Date Issued :	July 21, 2022	PCN Number :	512073
Reason for Change :	Change to Product		
Description of Change :	This letter is inform you that our supplier is updating the internal pair wire color of servo cables 6 circuits, series 155311-155321 – from black & black to black & white, diameter of insulation from 2,15 to 2,40mm, position of yellow/green core and external diameter changed from 11,1 to 11,3mm.		
Reason for Short Notice :	Force Majeure		
Assessment of Change :	First Article Inspection		
Planned Implementation Date :	September 30, 2022		
Sample Availability Date:	September 23, 2022		
Internal Molex Qualification Date :	September 23, 2022		
Last date to request Samples by Customer :	September 23, 2022		
Traceability Code Markings / Date :	No special marking on the product or packaging

▪ SERVO CABLES 155311-155321 – WIRE PAIR COLOR CHANGE

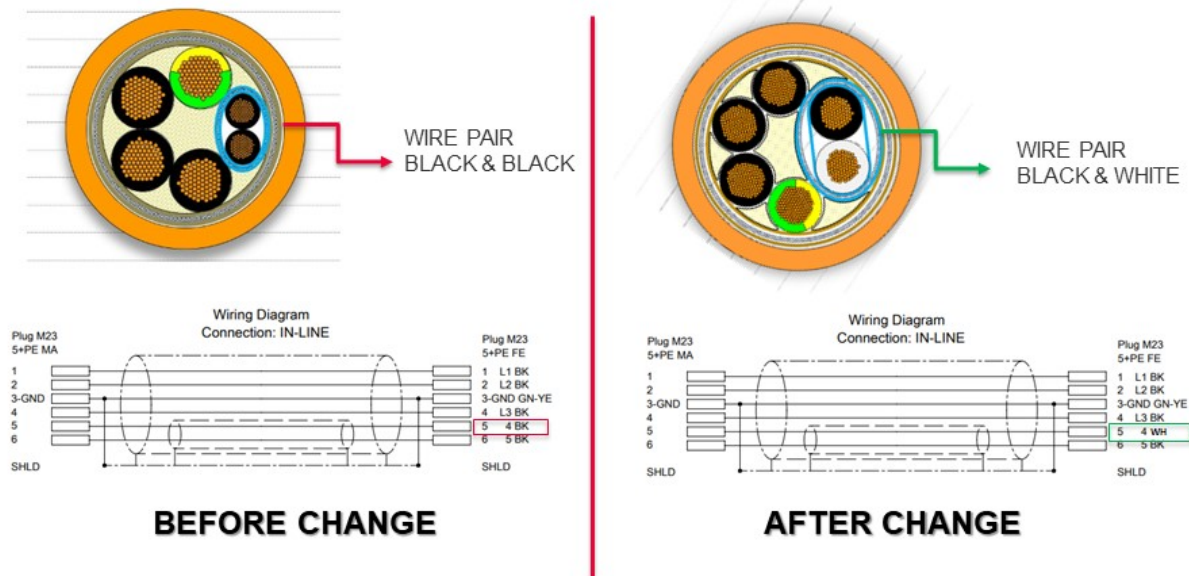
- This document is to inform you that our supplier is updating the internal pair wire color of servo cables 6 circuits, series 155311-155321 – from black & black to black & white, diameter of insulation from 2,15 to 2,40mm, position of yellow/green core and external diameter changed from 11,1 to 11,3mm.
- The purpose of this change is to align to the most commonly coloration used in the market for such cables.
- The change have impact on fit and form of the product.
- See attached the impacted parts list.
